UNITED STATES PATENT AND TRADEMARK OFFICE

09/895,198

Office Action Summary	Application No. 09/895,198	Applicant(s) MULLER ET AL.	
	Examiner HOA B. TRINH	Art Unit 2893

DETAILED ACTION

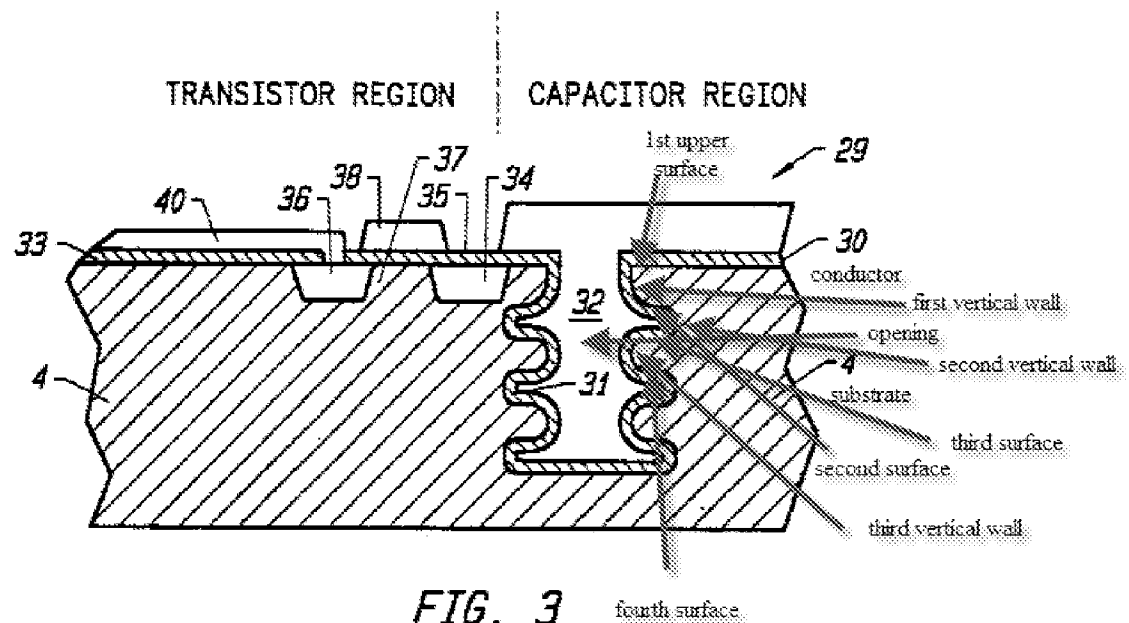
Regarding claim 45, in figure 3, Rostoker discloses an integrated circuit structure comprising: a substrate 4 having an upper surface, wherein said substrate 4 comprises a substrate material; an opening 32 in said upper surface of said substrate defined by said substrate material; a second surface parallel to and at a depth less than said upper surface; a third surface parallel to and at a second depth less than said second surface; a first

vertical wall substantially orthogonal to and intersecting said upper surface at said opening and said second surface; a second vertical wall substantially orthogonal to and intersecting said second and said third surfaces; and a conductor 30 filling said opening, wherein said second vertical wall is positioned in a vertical direction within a horizontal dimension of said opening 32. see marked-up figure 3 below.

Regarding claim 46, said second surface is positioned in an upward direction. See marked-up figure 3.

Regarding claim 47, first and second vertical walls are symmetrically disposed from said first and second vertical walls on an opposite side of a centerline of said opening 32. See marked-up figure 3.

Regarding claim 48, said upper, second and third surfaces each intersect their respective first and second vertical walls at substantially right angles. See marked-up figure 3.

Regarding claim 49, as best understood, an intersection of said second vertical wall and said second surface is coplanar in a horizontal direction with an intersection of said second vertical wall and said third surface. See marked-up figure 3.

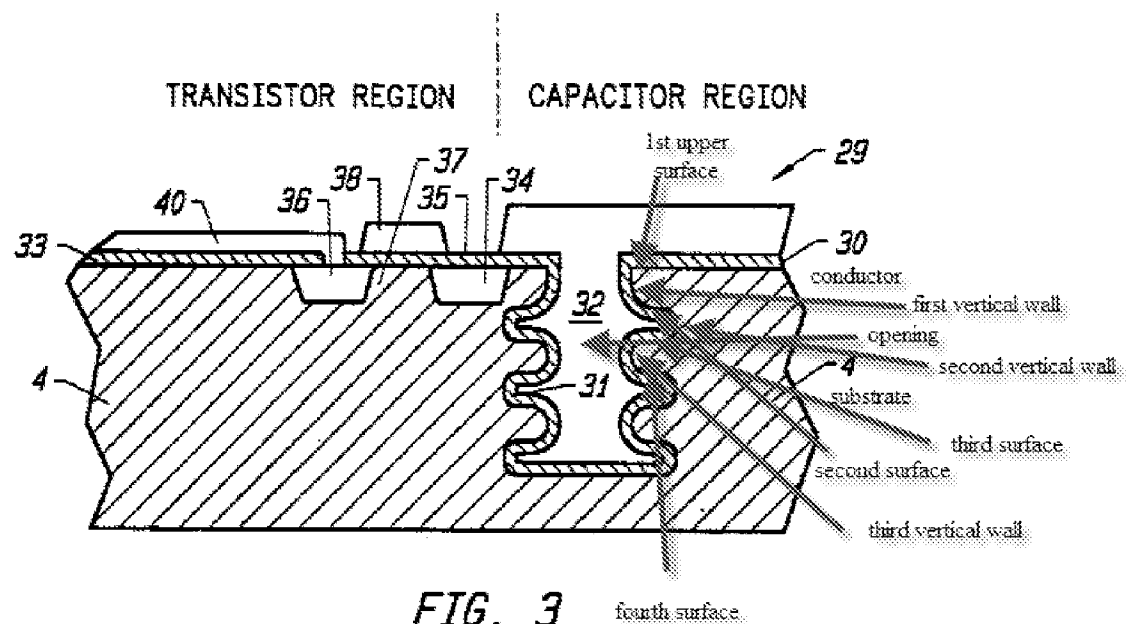
Regarding claim 50, in figure 3, Rostroker discloses an integrated circuit structure comprising: a substrate 4 having an upper surface, wherein said substrate 4 comprises a substrate material; an opening 32 in said upper surface of said substrate 4 defined by said substrate material; a second surface parallel to and at a depth less than said upper surface; a third surface parallel to and at second depth less than said second surface; a fourth surface parallel to and at a third depth less than said third surface; a first vertical wall substantially orthogonal to and intersecting said upper surface at said opening and said second surface; a second vertical wall substantially orthogonal to and intersecting said second and said third surfaces; a third vertical wall substantially orthogonal to and intersecting said third and fourth surfaces; and a conductor 30 filling said opening 32, wherein said second vertical wall is positioned in a vertical direction within a horizontal dimension of said opening 32, and wherein said third vertical wall is positioned vertically between a horizontal dimension of said opening and said second vertical wall. See marked-up figure 3.

Regarding claim 51, said second and fourth surfaces are positioned in an upward direction. See marked-up figure 3.

Regarding claim 52, said third surface is positioned in a downward direction. See marked-up figure 3.

Regarding claim 53, corresponding first, second and third vertical walls are symmetrically disposed from said first and second vertical walls on an opposite side of a centerline of said opening. See marked-up figure 3.

Regarding claim 54, said upper, second, third and fourth surfaces each intersect their respective first, second and third vertical walls at substantially right angles. See marked-up figure 3.
